**RFP-2526-538 Addendum 1
Construct and Install Elevator
May 27, 2026**

Danville Public Schools
Glenwood School Campus -Elevator Addition
RFP – 2526-538
Addendum No. 1
May 27th, 2026

Panel MDP

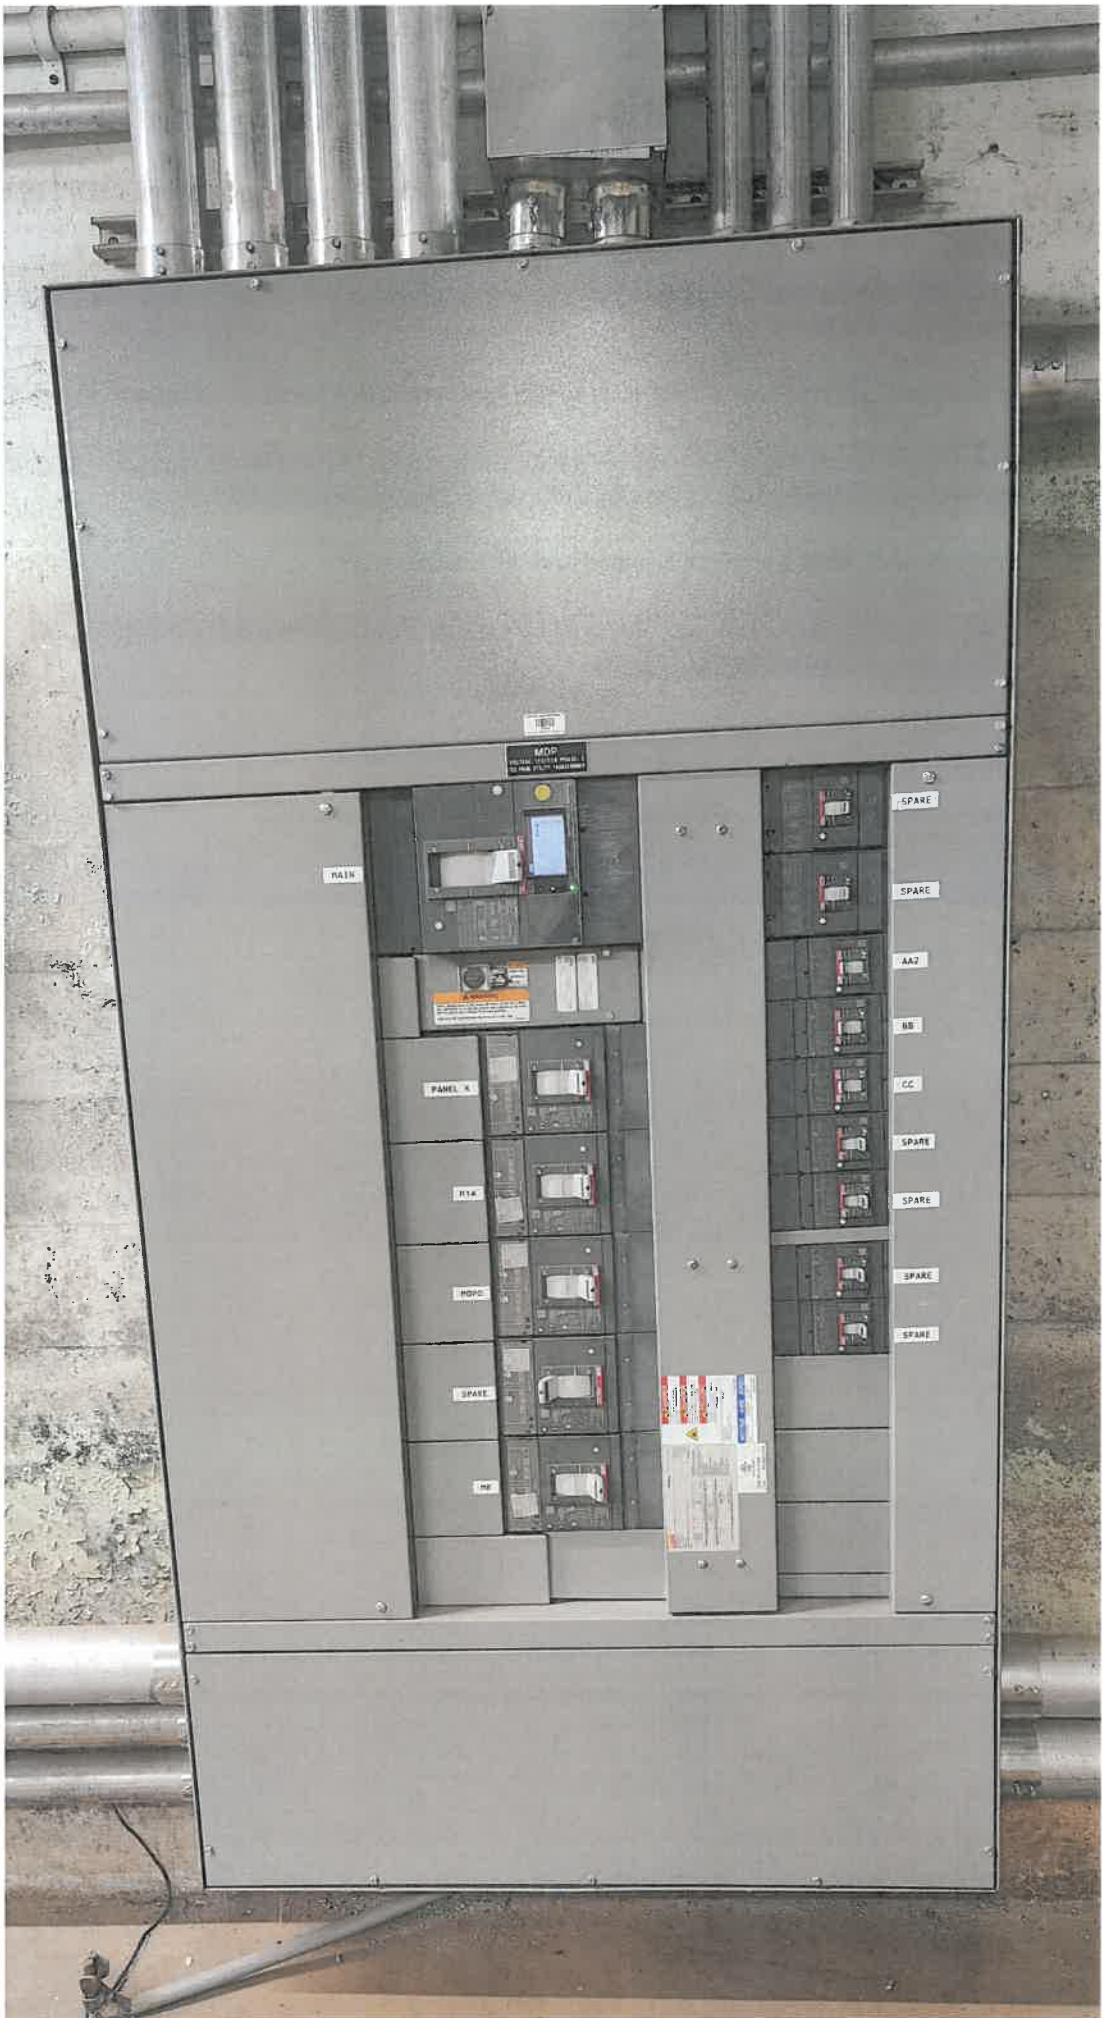
Item No.4; Drawing Sheet E101; Plan Note #3 stated to provide a new breaker in Panel MDP, IS there any information available on this panel?

Item No.5; Is there any information available as to the location of this panel in relation to the elevator?

Response: Panel MDP is a 208V, 3-phase, 1200A, with main breaker, ABB panelboard located in the basement. See pic enclosed.

Response: Basement was not modeled in Revit for this project. See enclosed sketched at end of this addenda for rough estimate for the layout of the basement and panel MDP.
